MONTGOMERY COUNTY HISTORIC PRESERVATION COMMISSION
STAFF REPORT

Address:	22 West Irving Street, Chevy Chase	Meeting Date:	11/15/2023
Resource:	Contributing Resource Chevy Chase Village Historic District	Report Date:	11/8/2023
Applicant:	Andrew and Katie Herman (Luke Olson, Architect)	Public Notice:	11/1/2023
Review:	HAWP	Tax Credit:	No
Permit Number:	1048008	Staff:	John Liebertz

PROPOSAL: Partial demolition, construction of new side entrance, new two-story rear addition, hardscape alterations, accessory structure alterations and new storm door.

Figure 3: Detail of the chamfer nosing trim.

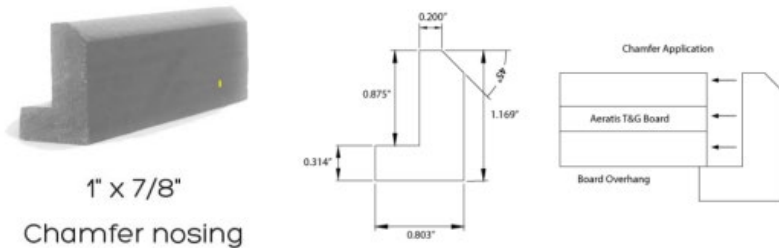
Staff finds that the proposed stoop (side entrance) and stair meet the applicable guidelines and recommends approval with conditions. Most of the stoop and stair would be located on the west (side) elevation of the existing 2011 addition. A very small section of the stair (approximately two treads) would be adjacent to the historic section of the house. The applicant proposes the installation of Aeratis Traditions—solid extruded polyvinyl chloride—tongue and groove decking and cellular polyvinyl chloride posts and balustrades. While the proposed stoop and stair (and substitute materials) would have greater visibility from the public rights-of-way than the rear deck, its distance from the street and location adjacent to new construction minimizes adverse effects to the individual resource or the surrounding district. Per the *Guidelines*, the stoop/stair should be reviewed under “moderate scrutiny” which permits for the use of compatible materials when appropriate. Similar to the rear deck, staff requests that the applicant include a note or detail that shows the installation of the optional “chamfer nosing” trim piece that covers the end joints of the boards.

2. The applicant shall submit specification for all the aluminum-clad, wood doors proposed on the house and garage.
3. The applicant shall install the optional "chamfer nosing" trim on all solid extruded polyvinyl chloride tongue and groove decking.

PROPOSED SITE PLAN
SCALE = 1:20

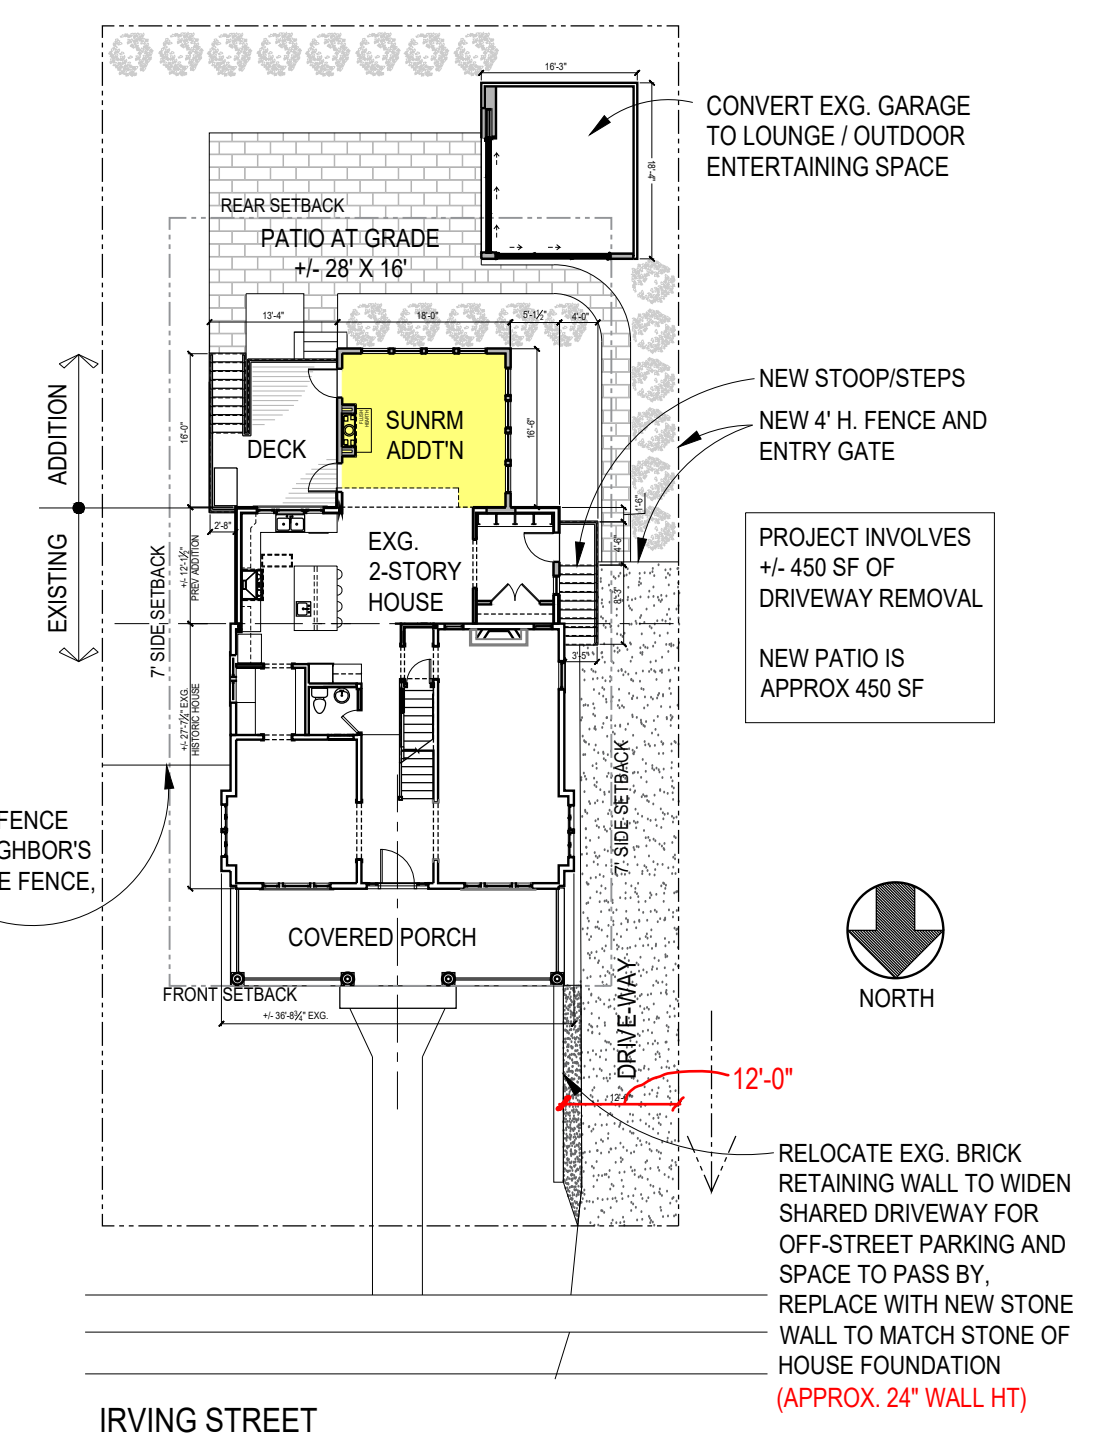
Staff finds that the proposed picket fence and privacy fence meet the applicable guidelines and recommends approval with conditions. The 4’-tall picket fence and gate would be located at the terminus

of the driveway (adjacent to the proposed side entrance). Staff requests the applicant label all fence materials (boards, post caps, etc.). The privacy fence on the eastern side of the property would match the design and materials of the neighbor's adjoining privacy fence. Staff requests additional information about this fence including the proposed dimensions and materials (boards, post caps, etc.). In addition, staff recommends that the applicant move the fence to the rear wall of the historic house as stipulated by the commission in the approval of privacy fences. This condition maintains the park-like setting of the historic district as direct by the *Guidelines*.

7. The applicant shall submit specifications for all fence materials.
8. The applicant shall move the privacy fence to the south and align it at the rear wall plane of the original house.
